CENTER for SCIENCE in PUBLIC PARTICIPATION

October 8, 2020

Re: Stibnite Gold Project Draft Environmental Impact Statement

Figure 2.3-5 TSF and Hangar Flats DRSF General Cross Section

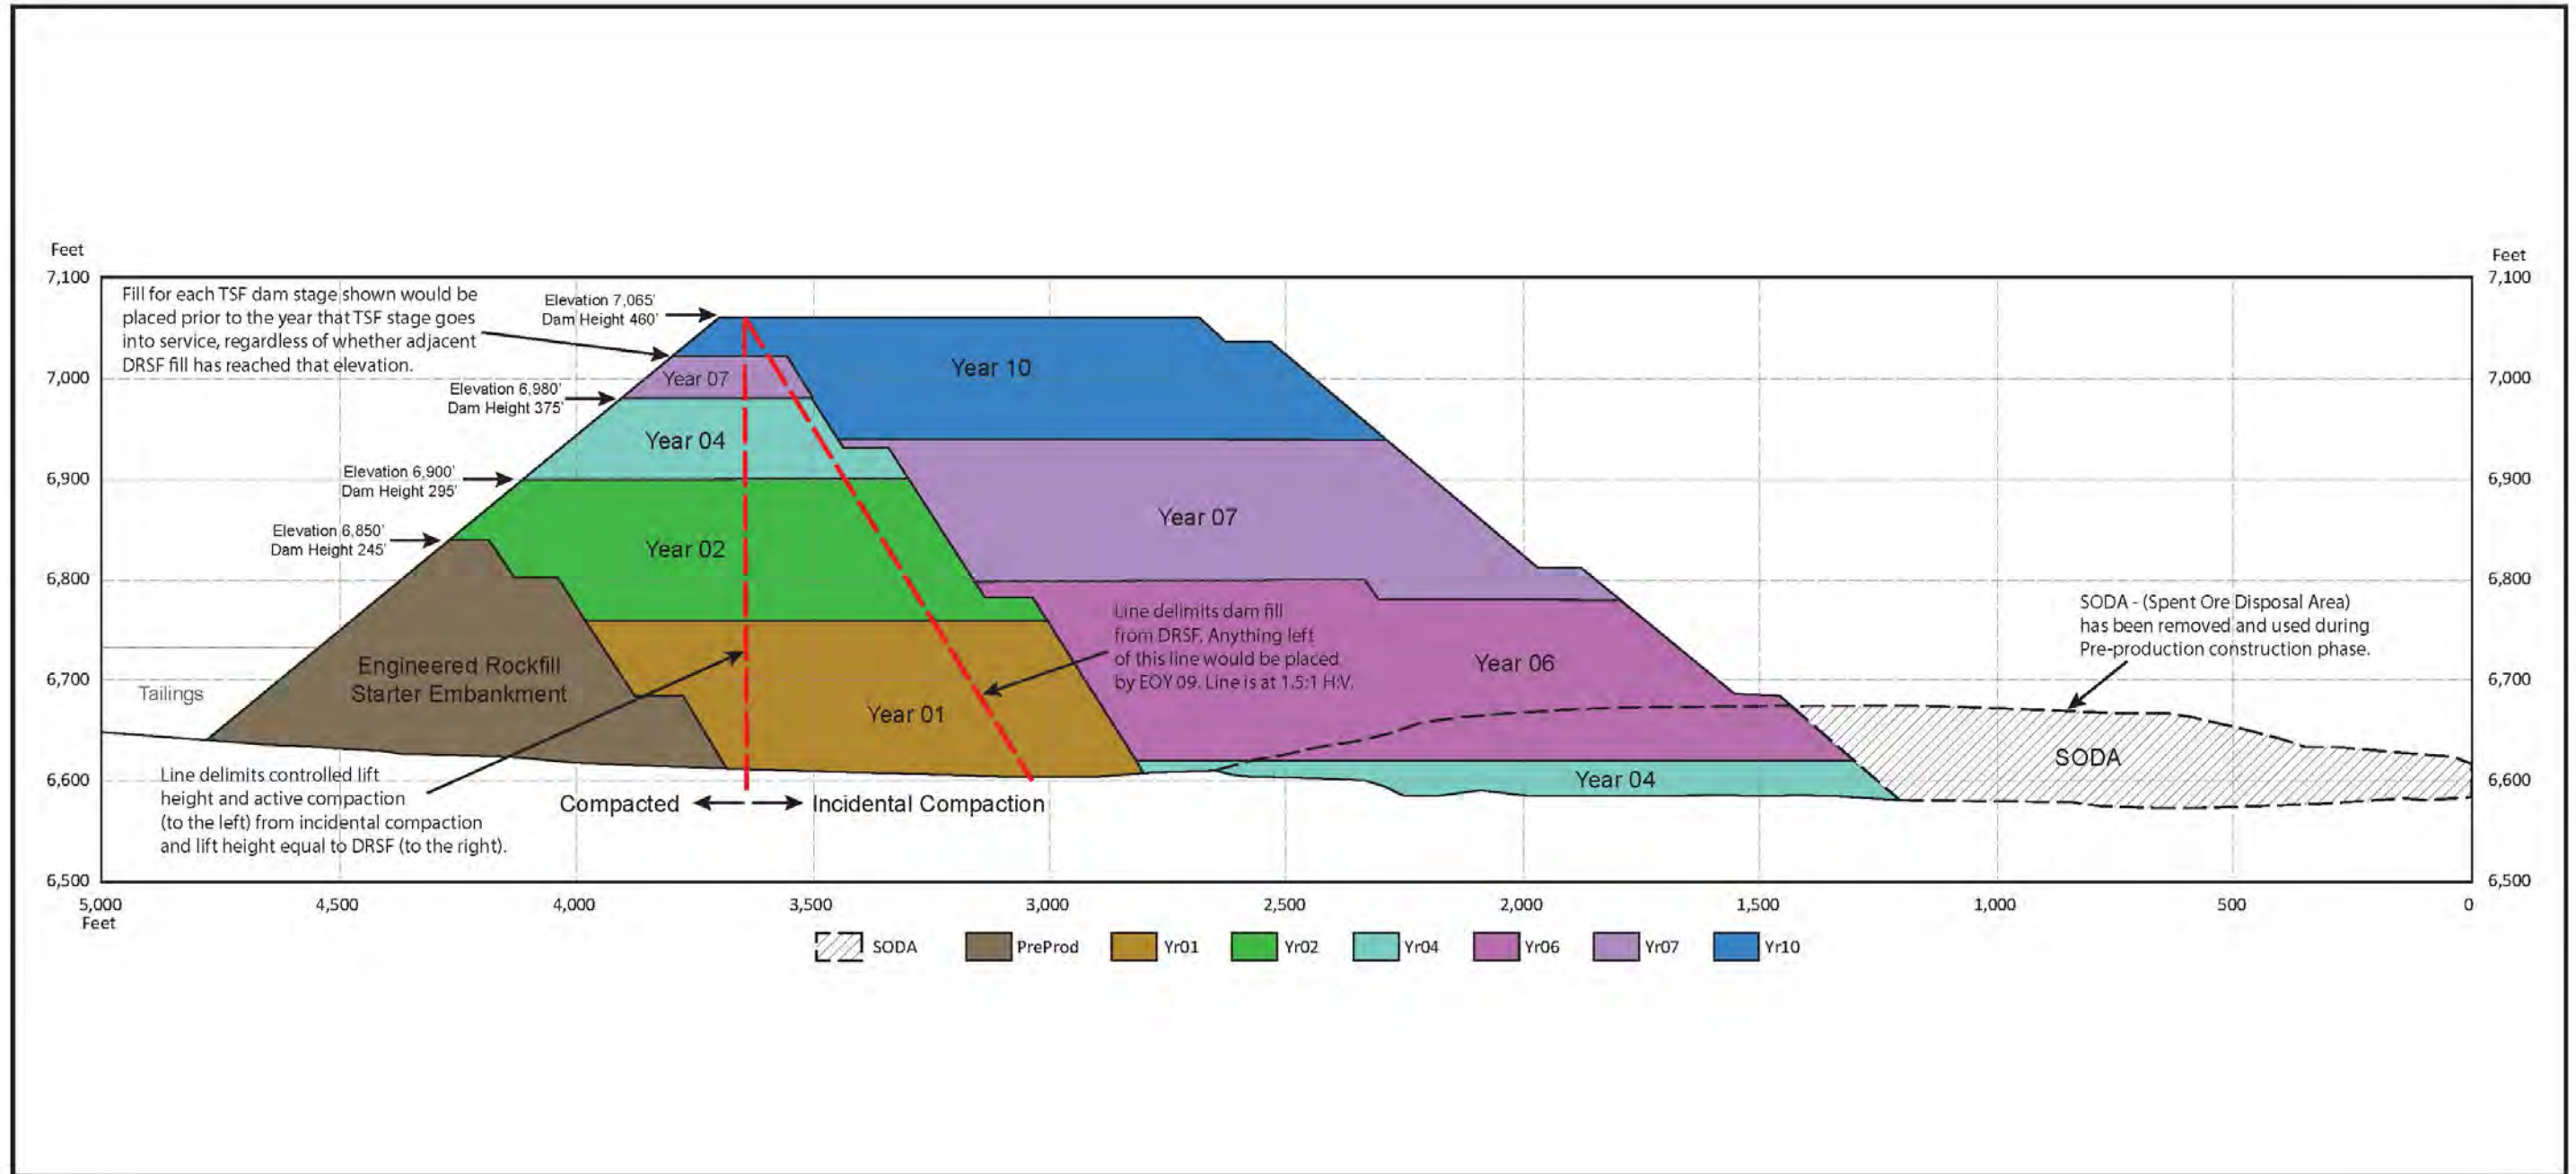
The tailings dam described in Alternative 1 is used to supply basic construction information on the dam for all of the alternatives with a Hangar Flats TSF location. There is no technical documentation provided on the dam construction. The cartoon dam depiction provided in Figure 2.3-5 TSF and Hangar Flats DRSF General Cross Section (attached), is not adequate to provide the basic information needed to review whether the dam construction proposed is adequate. The most detailed information on the tailings dam construction appears in the Prefeasibility Study (see Drawing 18.4: TSF Dam Cross-Section, attached), but neither is sufficient to answer basic questions about the dam construction that need to be addressed. These questions include: (1) how will the dam be constructed in a downstream manner given the simultaneous development of the Hanger Flats DRSF, which will not be compacted to engineering standards; and, (2) will the proposed construction approach allow for expansion of the tailings facility in a downstream manner, or will dam expansion be limited to upstream-type development?

Recommendation: Technical documentation on the construction sequencing must be included in the EIS, and dam safety specifications and construction quality assurance requirements must be supported with technical documents. This information is missing at present.
